DEVELOPMENT APPLICATION

PDPLANPMTD-2023/038817

PROPOSAL: Additions and Alterations to Childcare Centre
(Educational and Occasional Care)

LOCATION: 2C Loinah Road, Montagu Bay

Drawing
EXISTING SITE PLAN 02

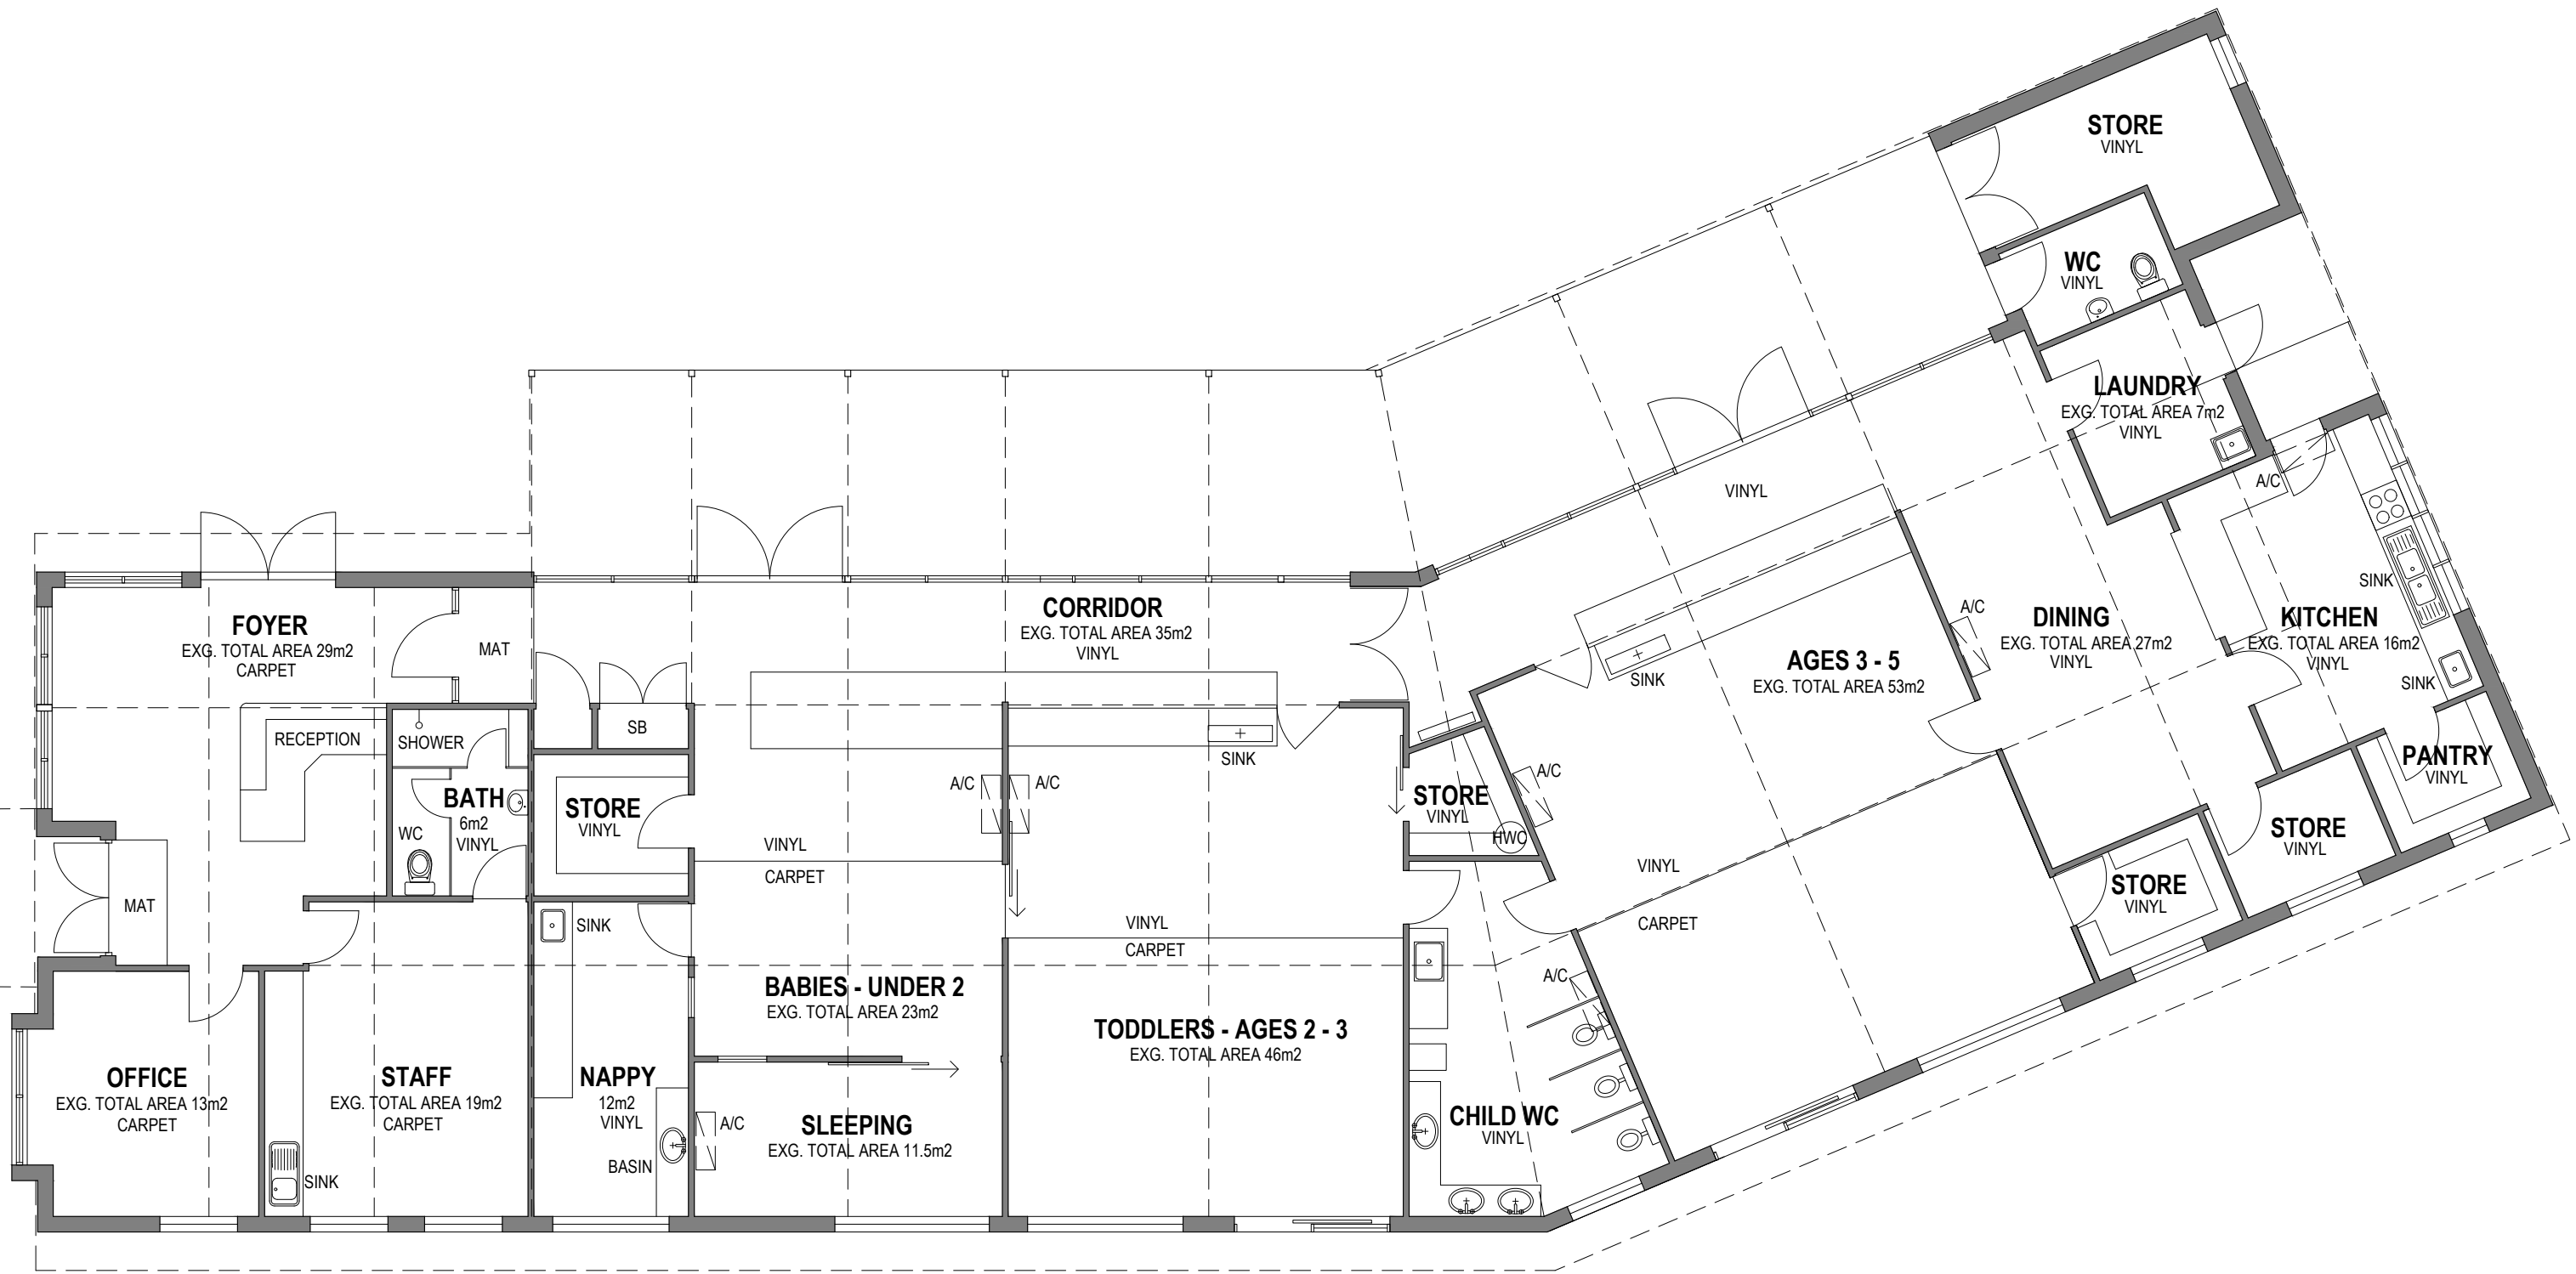
- The proposal refers to amendments of the existing car parking space to the north of the building. The manoeuvring and circulation areas appear to have a gravel surface treatment, which does not meet the construction of parking areas requirements under the Car Parking and Sustainable Transport Code. The proposed changes to the building do not trigger the need for additional parking spaces. Please clarify if the amendments to the parking area are to be included in the application, noting that if changes are proposed to the area, Council may require the area to be sealed.

No alterations to the existing parking (beyond the DDA parking now deleted) is shown on the drawings. An attempt has been made to tally the existing parking on site to demonstrate the current level of parking available. This is why the existing spaces have been numbered.

Drawing
PROPOSED SITE PLAN 02

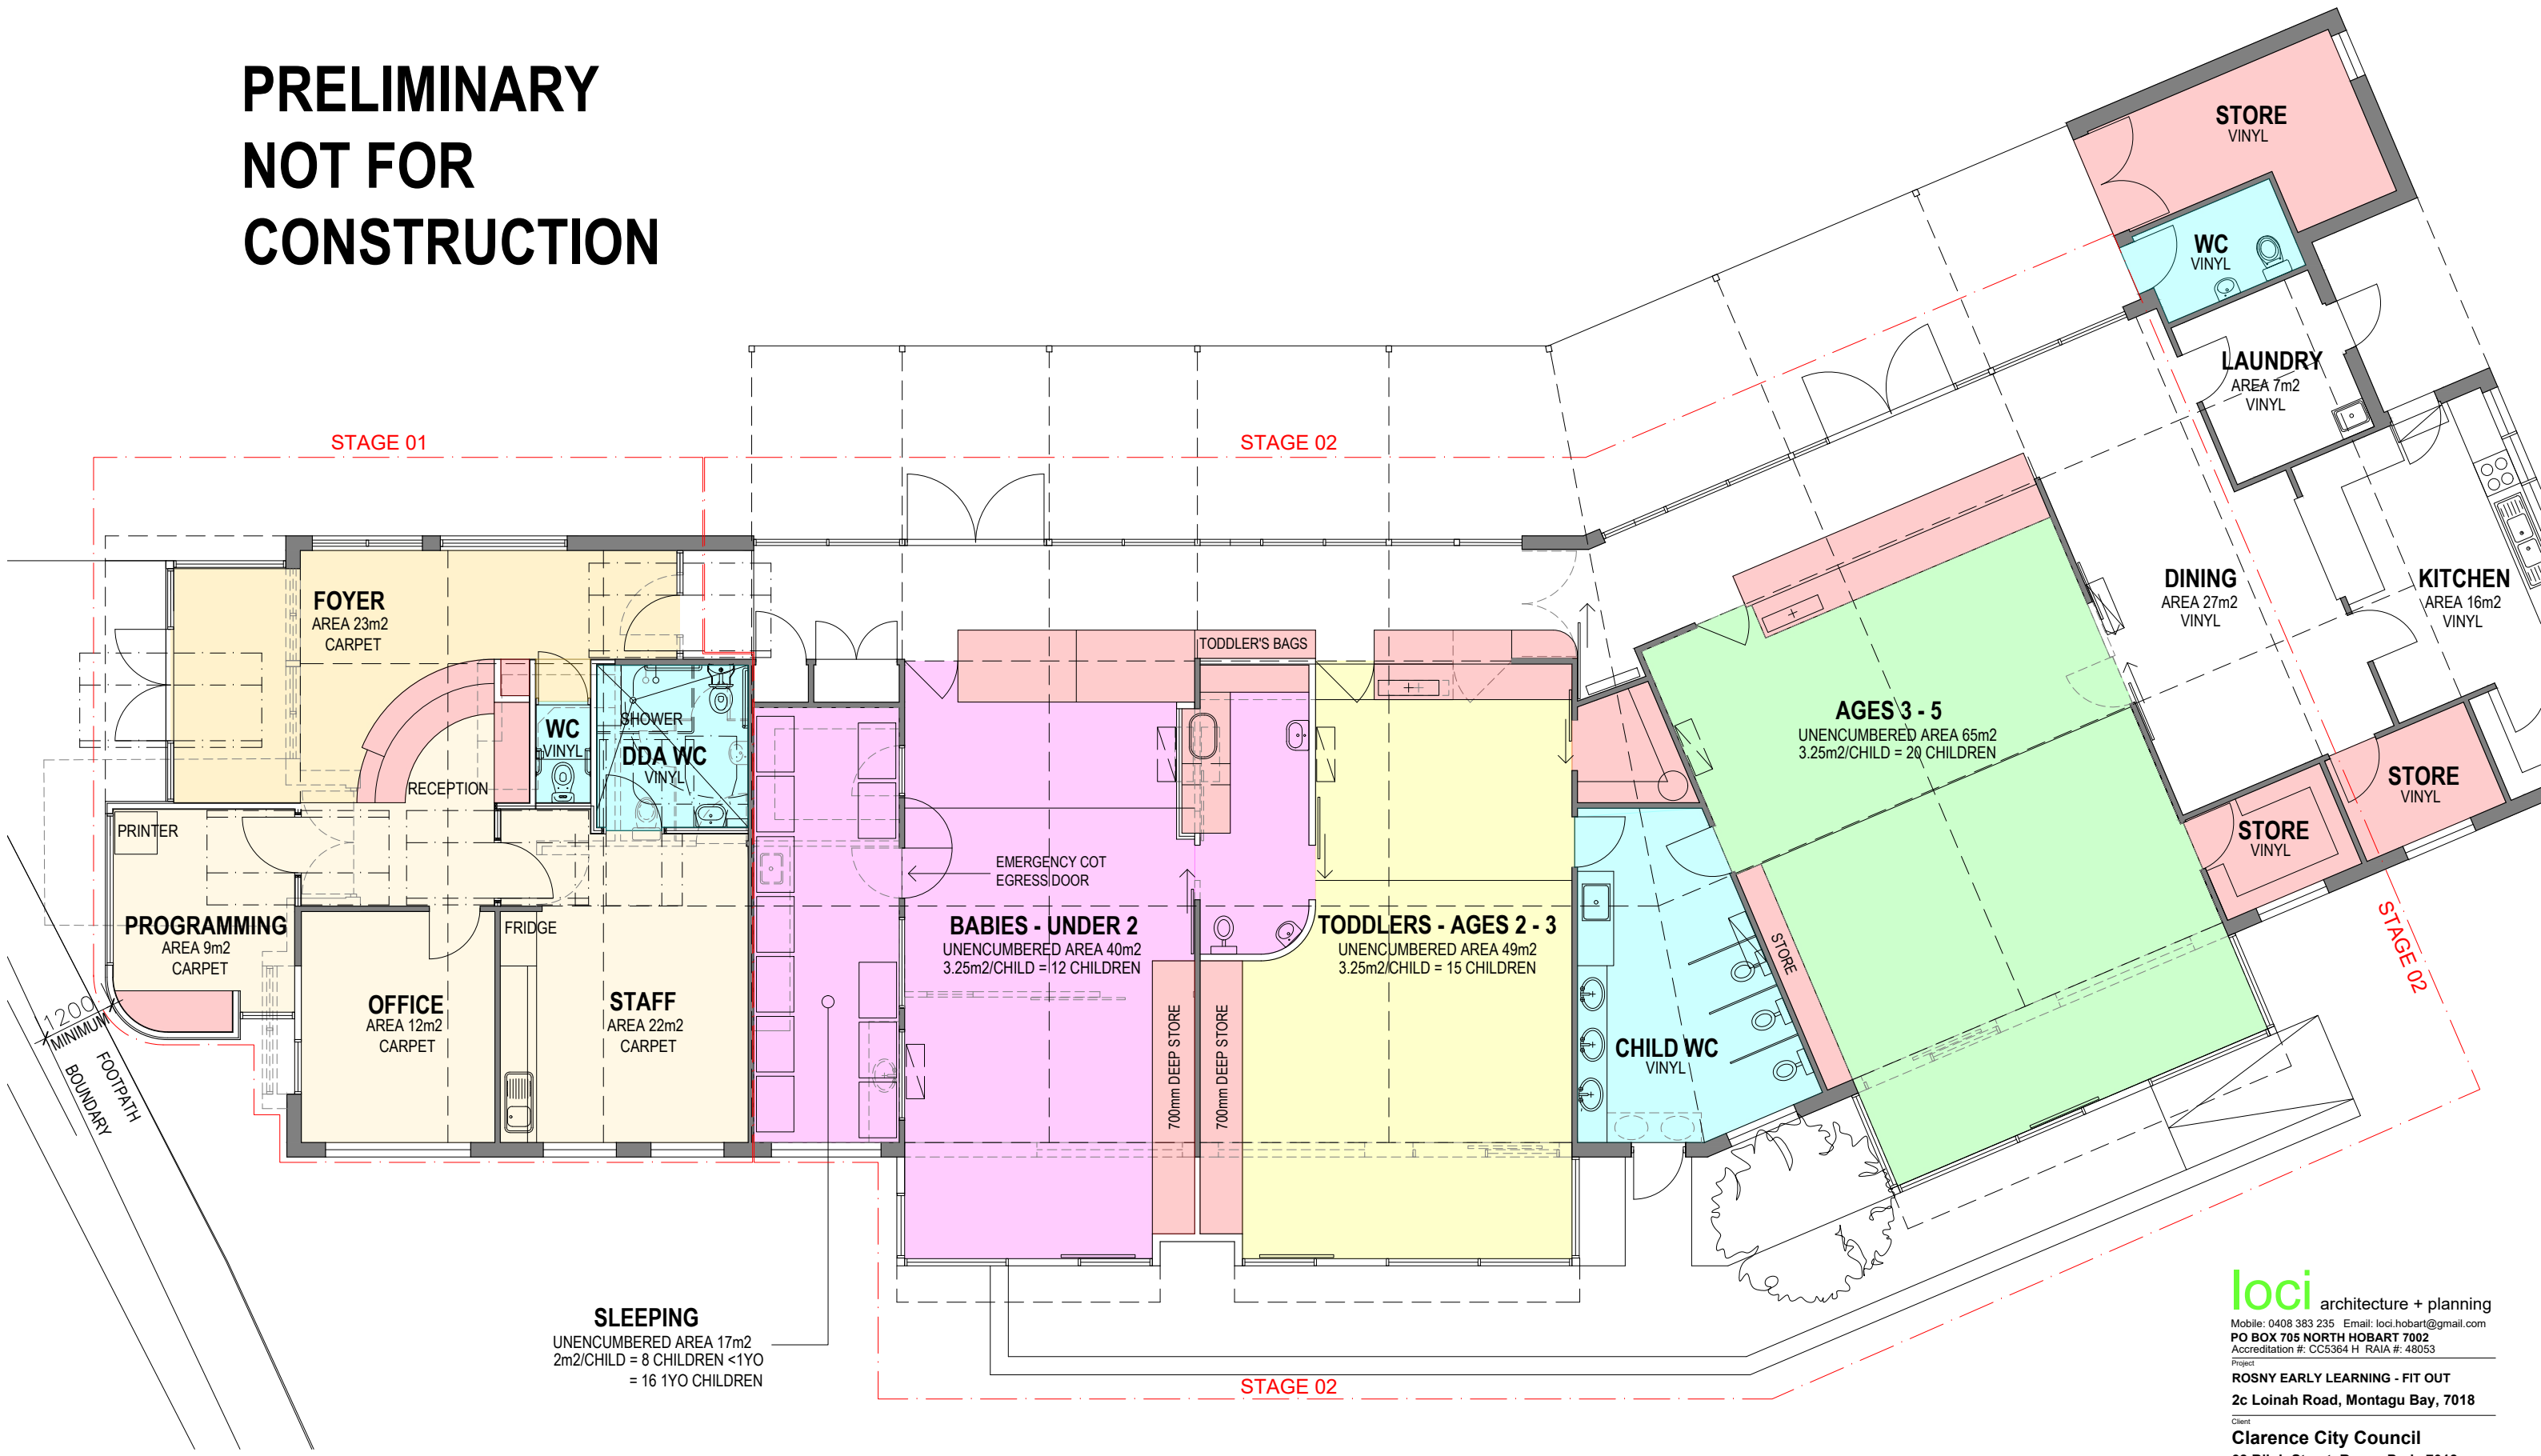
- The proposal includes the conversion of three regular parking spaces into two DDA car parking space. It is noted that these parking spaces do not comply with the standards for DDA parking spaces in relation to the gradient and the car parking depth. Please provide compliant DDA car parking space as required under AS2890.6.

- It is noted that Council believes that the proposed development does not trigger a requirement for the provision of DDA car parking spaces and you therefore may choose to remove the DDA parking spaces from the proposal. If you choose to do this, we suggest that you confirm your DDA parking obligations with a building surveyor beforehand.

The previous iteration of the drawings showed one DDA car parking space. I have consulted with the project Building Surveyor Nigel Grice, who has confirmed that due to the size of the development (less than 25% extension and less than 50% works to the existing building) a DDA space is unlikely to be required for Certificate of Likely Compliance (Building Permit) assessment. Please see attached correspondence with Holdfast Building Surveyors and revised drawings Revision B.

See above.
